**PLANS AND DOCUMENTS
referred to in the PDA
DEVELOPMENT APPROVAL**

Approval no: DEV2022/1334
Date: 28 August 2023

RE: 67 and 69 Shore Street East, Cleveland – Multiple Dwelling Residential Development – Transport Engineering Assessment (EDQ Reference: DEV2022/1334)

Snapshot 2

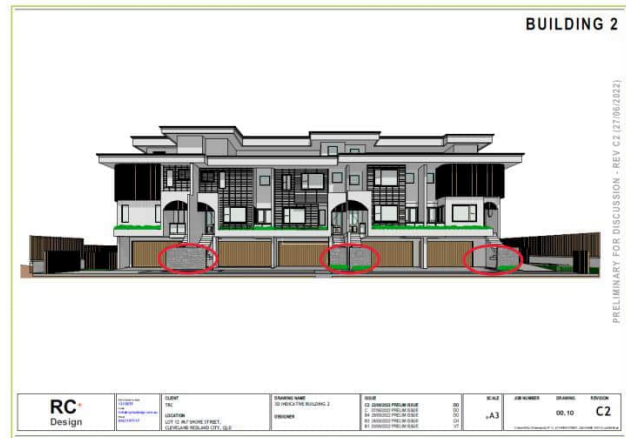
- c) Adequate sight distance and queuing provisions at the driveway;
- d) A fully dimensioned scale plan, including gradients, for the access and carparking areas;
- e) The 6.3m wide aisle width includes delineated footpath. Ensure the driveway aisle width is 5.8m in accordance with AS2890;
- f) The delineated footpath appears to encroach into the aisle between Unit 3 and 5, please see the below snapshot 1;
- g) Units 4 - 8 staircases appear to encroach into the entry of the garages, please see the below snapshot 2;
- h) Reverse movement to and from Building 2 parking spaces at each end of the building would collide with the structural column / entrance stair, please refer to snapshot 2. Amendment required to design to address this matter.

- **RFI Item 14 – Driveway Aisle** – The development provides a minimum of 6.3m aisle (5.1m dedicated driveway and 1.2m pedestrian pathway) width to facilitate access in/out of car parking spaces and garages that satisfy AS2890.1:2004.

- **RFI Item 14 – Delineated Footpath:** It is acknowledged that the pedestrian pathway encroaches into the aisle between TH 3 and 5. However, this is not considered a significant issue given the following:

PROJECT
67 & 69 SHORE STREET EAST, CLEVELAND
DRAWING TITLE
SWEPT PATH ANALYSIS - UNIT 07
4.91m (B85) MEDIUM CAR MANOEUVRE FOR ENCLOSED GARAGE

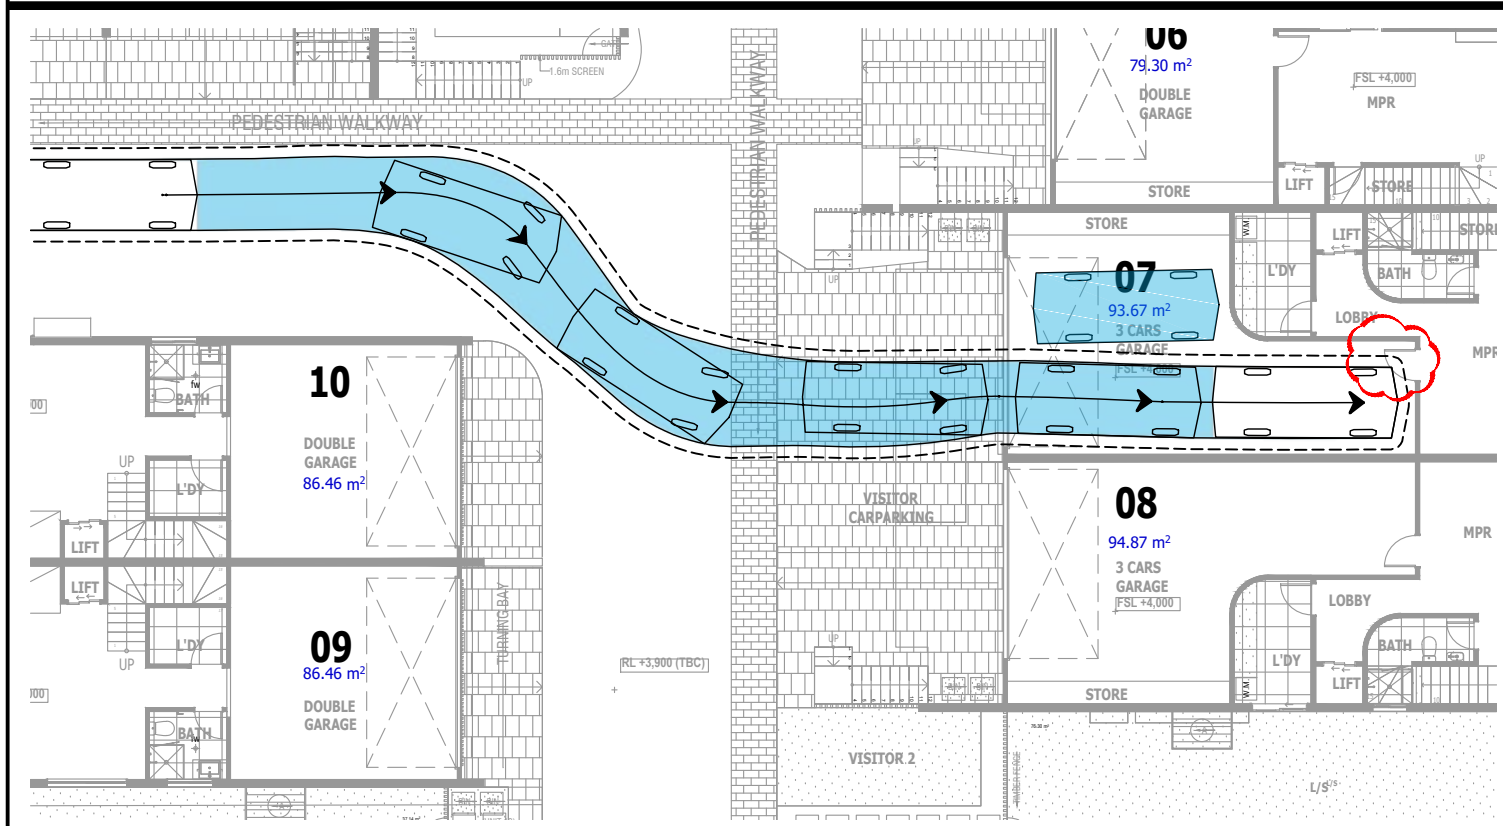
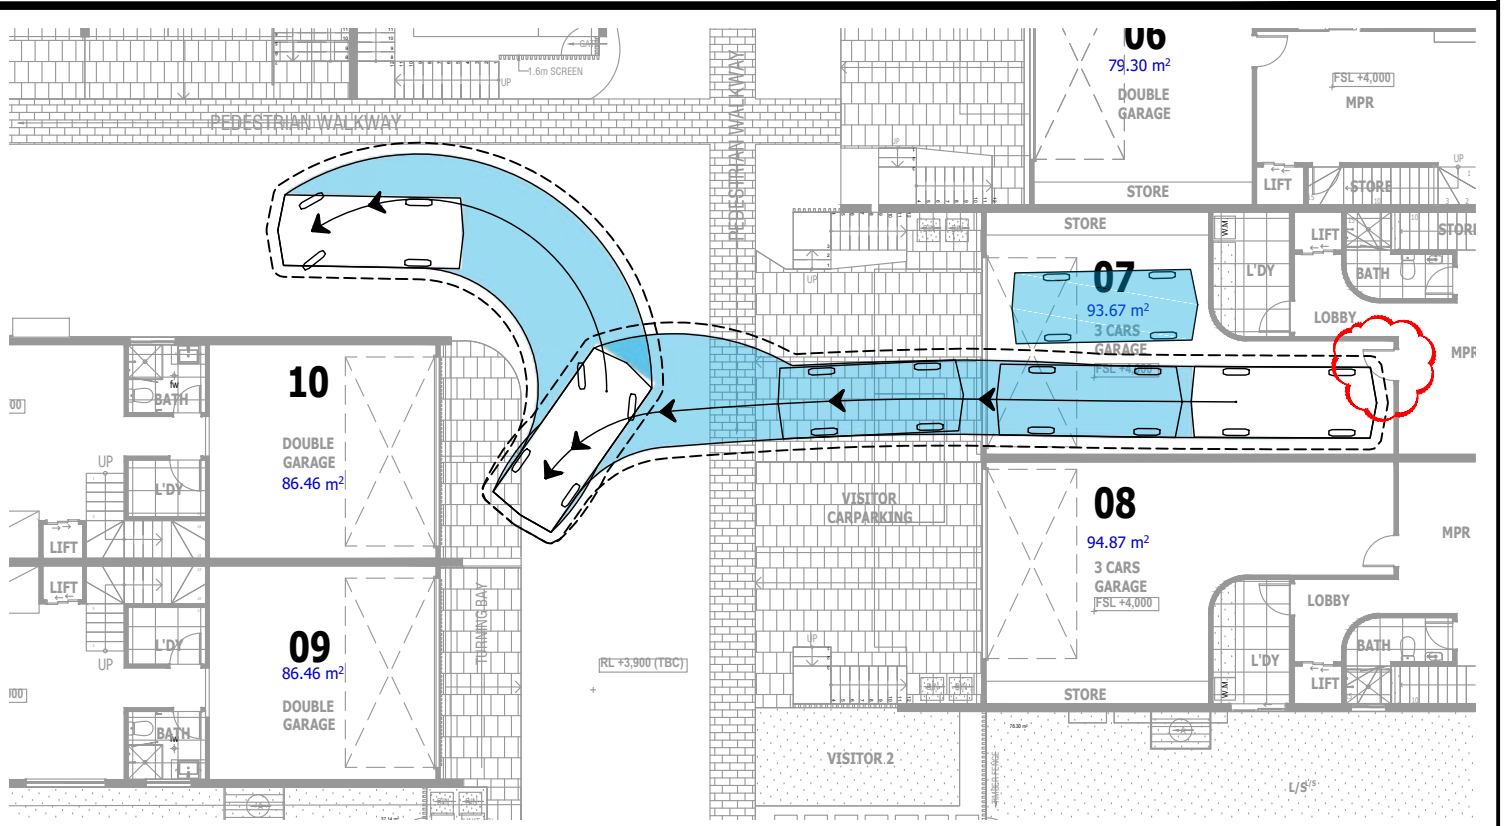
- It is noted that the pedestrian door opening within the garages for TH7 and 8 encroach on the trapped tandem car parking space. As such, it is recommended that the pedestrian door be modified to open inward or to converted to a pocked/sliding door.

- **RFI Item 14 – Staircase Encroachment:** The architectural plans have been updated to reduce encroachment from the stairs and to ensure garages can still be accessed as demonstrated on the manoeuvring plans included in Attachment B.
- **RFI Item 14 – Manoeuvring:** The architectural plans have been updated to ensure unrestricted access into the garages and to remove collisions with structural elements and stairs. The manoeuvring of a 4.91m (B85) Medium Car within the car parking area and accessing visitors' spaces and garages are illustrated within Attachment B. As shown, sufficient area has been provided to allow for these vehicles to adequately enter and exit the car garages;
